# NON-MATERIAL AMENDMENT APPLICATION

November 2020  
Doc Ref. 682.SD.005C

Planning Permission 2018/5462/P NMA Document

Non-Material Amendment application document for planning permission 2018/5462/P (erection of 4x 3-storey, 3-bedroom dwelling houses with associated landscaping following demolition of existing 3x single storey garages.)

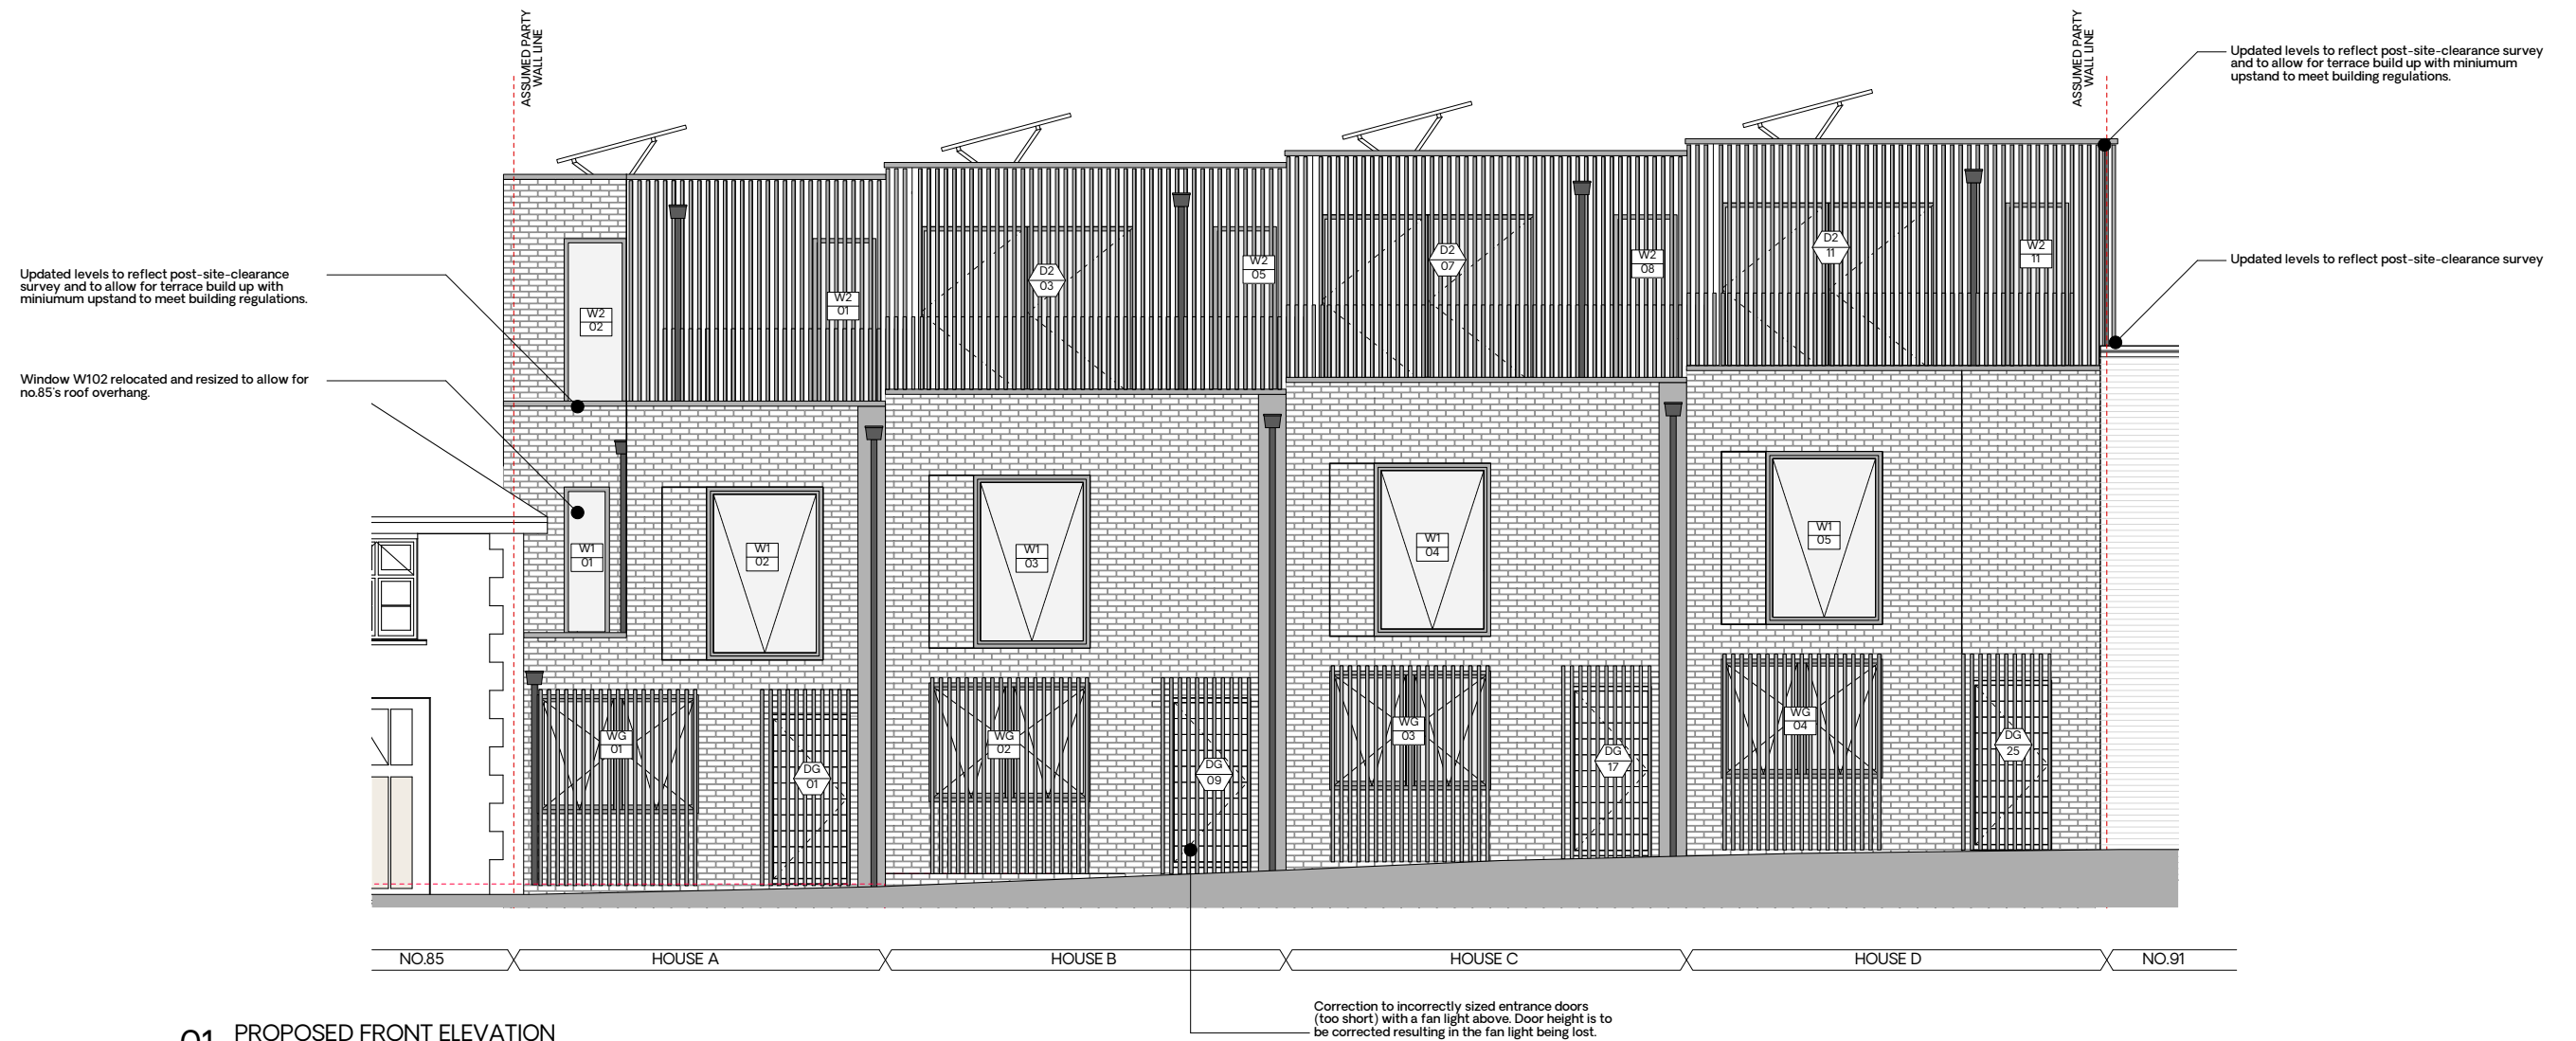
- Updated levels to reflect post-site-clearance survey and to allow for biodiverse roof build up to meet building regulations.
- General minor changes to layouts to comply with building regulations.
- Window W102 to front elevation relocated slightly and resized to allow for no. 85's roof overhang.
- Rear bi-fold door on house C decreased in height by two bricks for regularisation of bifolds across all terraces.
- Increased gradient of lean-to roofs to rear to allow for rainwater run off.
- 2F rear elevation window D212 decreased in width by approx. 300mm to fit in wall.
- 2F roof-light dimensions altered to allow for biodiverse roof edging.
- Correction to incorrectly sized entrance doors (too short) with a fan light above. Door height is to be corrected resulting in the fan light being lost.

01 PROPOSED REAR ELEVATION

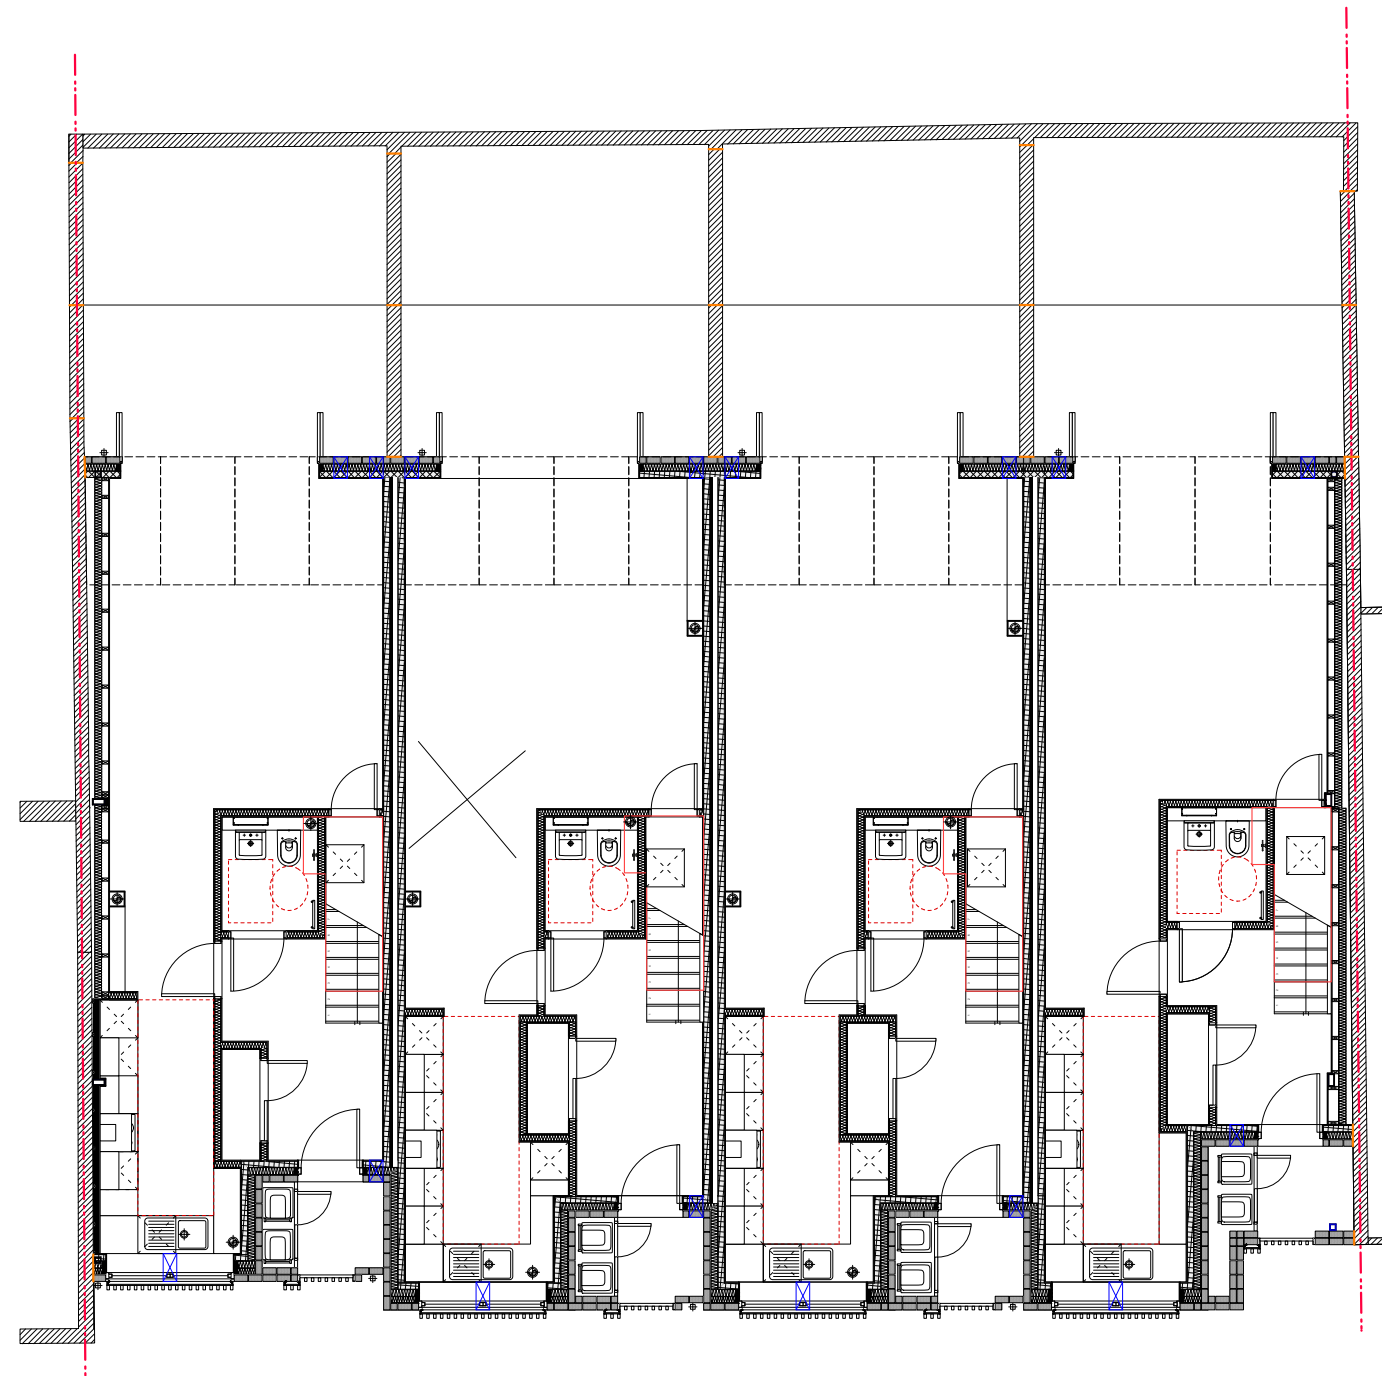
NB: LOCATION OF 2F WINDOWS MATCH THOSE SHOWN ON EXTANT PLANNING PLANS
